City of
Peterborough

Memorandum

File: 15T-14502/Z1418SB

**SUBJECT: Proposed Revisions to Application for
Draft Plan of Subdivision 15T-14502
2131222 Ontario Inc.
821, 825 and 829 Lily Lake Road**

REVISED
DRAFT PLAN OF SUBDIVISION
14T-14502
LILY LAKE ESTATES
PART OF LOT 11, CONCESSION 1
GEOGRAPHIC TOWNSHIP OF SMITH, NOW IN
CITY OF PETERBOROUGH
COUNTY OF PETERBOROUGH

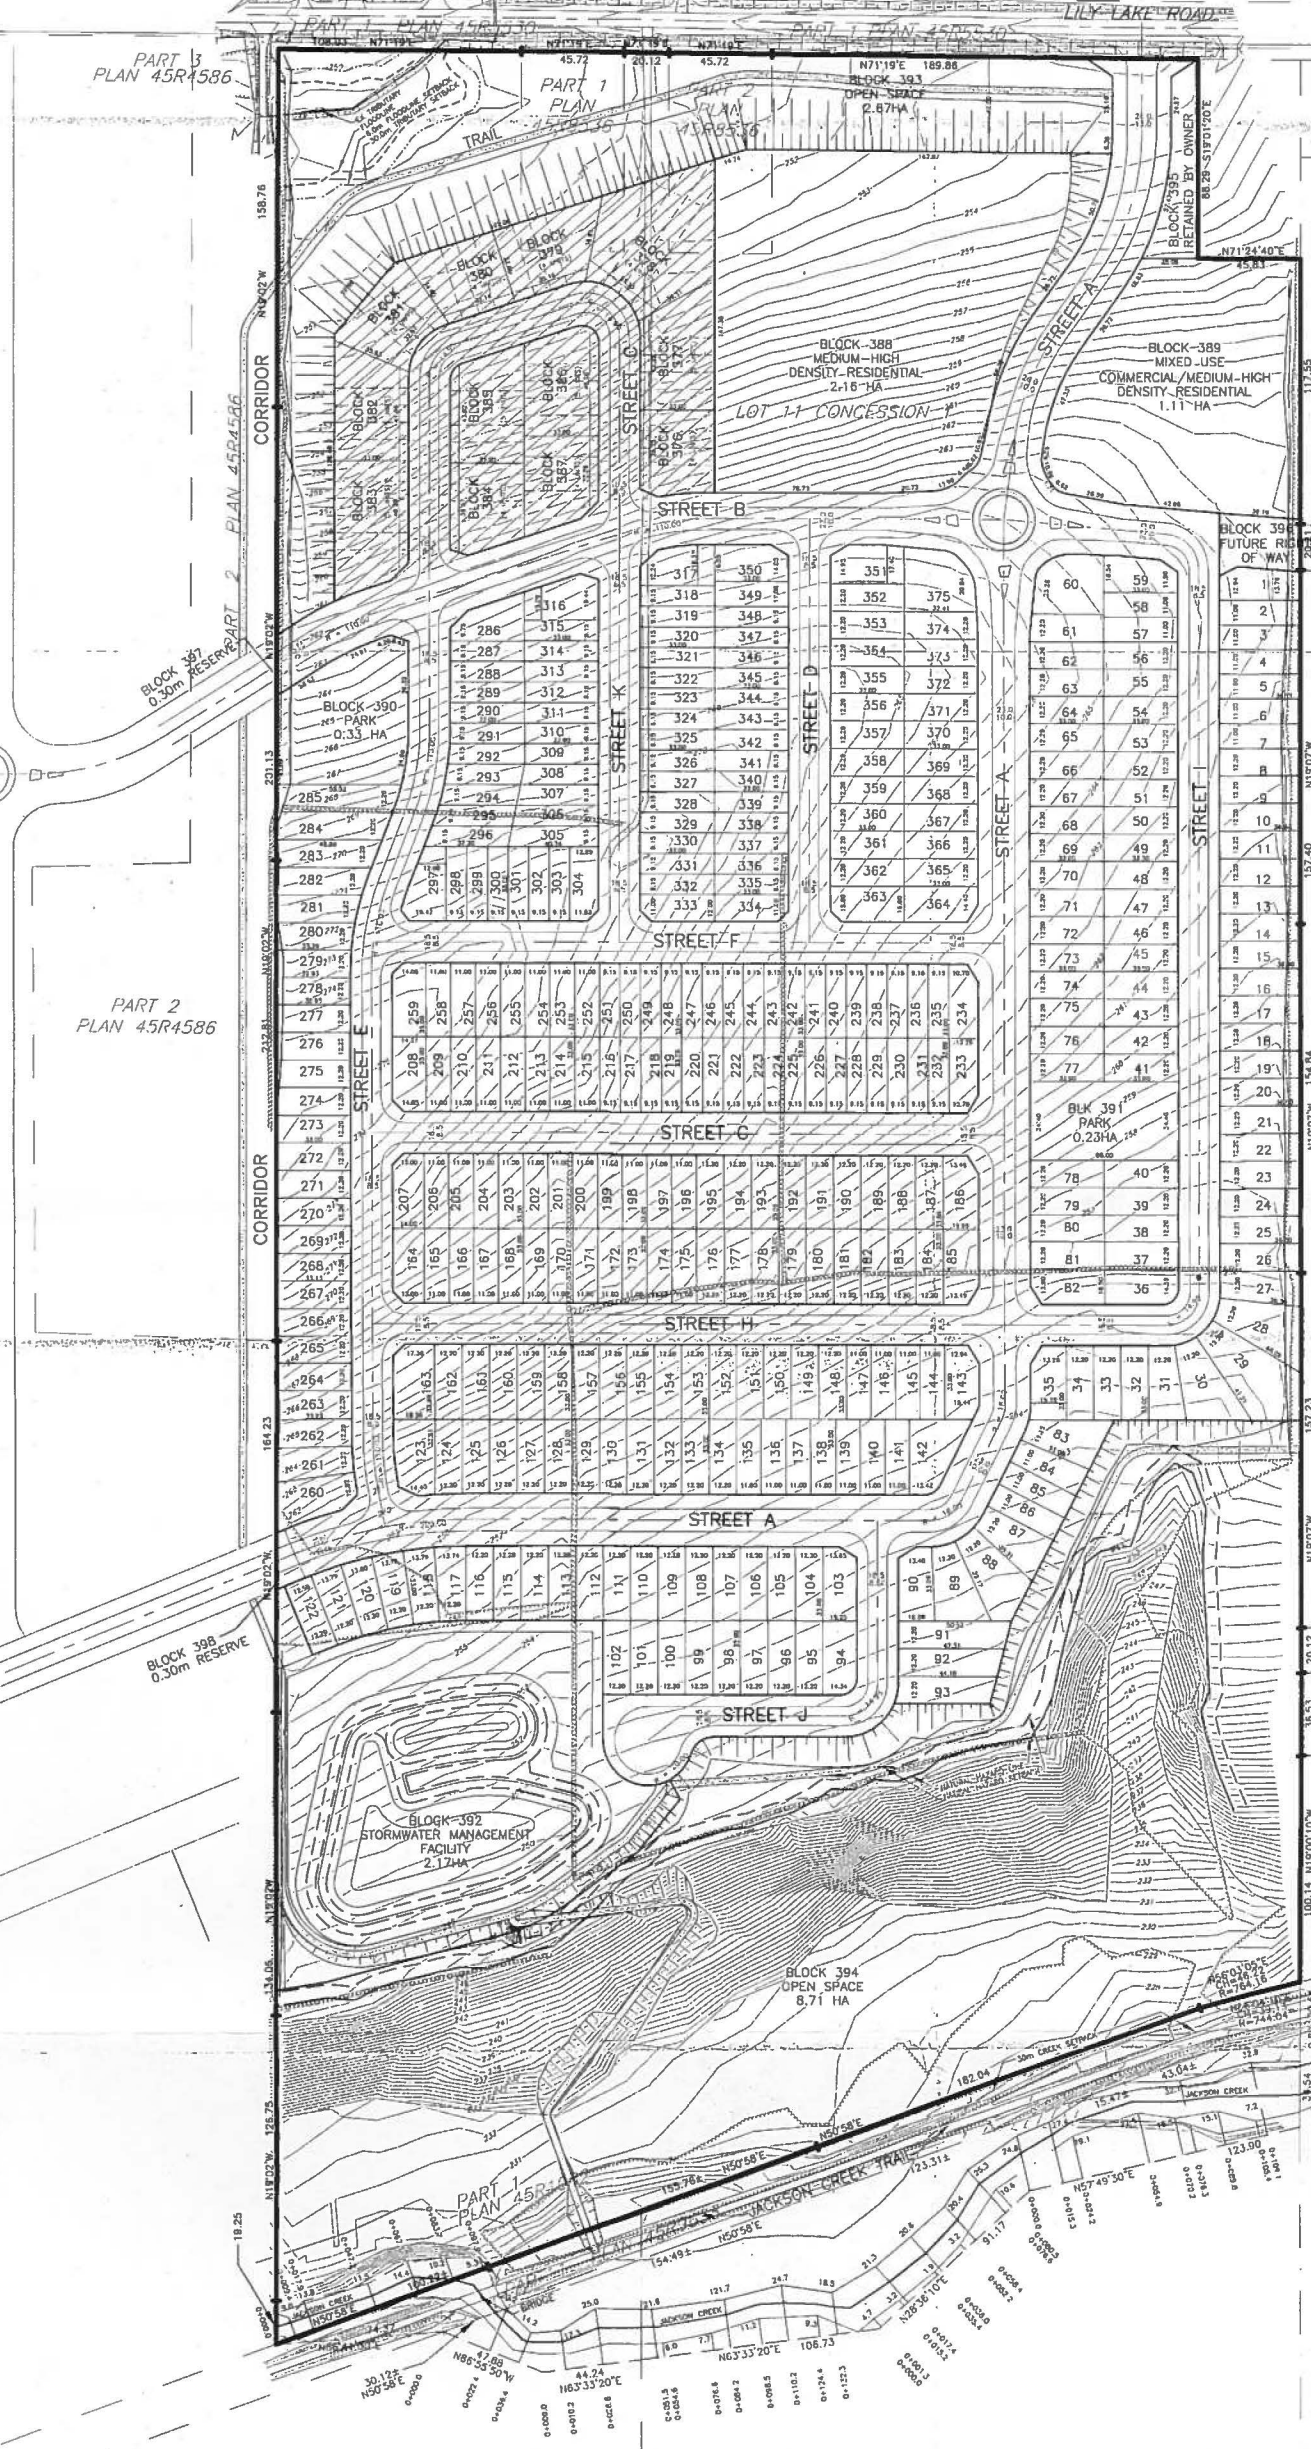
- Adds a roundabout to the intersection of Streets A and B;
- Realigns Street B to align with previously planned streets to the east;
- Moves the potential elementary school site to the north side of Street B, at the west limit of the plan;
- Moves the potential medium-high density residential block to the intersection of Streets A and B;
- Shifts the proposed commercial block to a new mixed-use commercial/medium density residential block on the east side of Street A;
- Shifts parkland from the east limit of the plan on Street B to the west limit of the plan on Street B to align with the proposed north-south open space corridor;
- Includes a small parkette between Streets A and I;
- Incorporates a series of north-south streets, south of Street B;
- Illustrates a conceptual trail network;

- Shifts the proposed stormwater management pond to the southwest corner of the site, above the Jackson Creek Valley;
- Introduces a single-sided cul-de-sac along the top of the Jackson Creek Valley
- Shifts a proposed north-south open space/trail corridor along the west limit of the site mostly onto adjacent lands to the west; and,
- Proposes lots with a minimum width of 12m or 40 feet along Collector Street A.

- 375 lots for single detached residential purposes;
- 53 street-fronting townhomes (if not used for school purposes);
- 176 medium density residential units;
- 50 medium density residential units combined with a potential 700 square metre commercial plaza;
- an elementary school;
- two parkland sites;
- open space lands within the Jackson Creek Valley and along Lily Lake Road;
- a stormwater management pond; and,
- a potential street connection to the east.
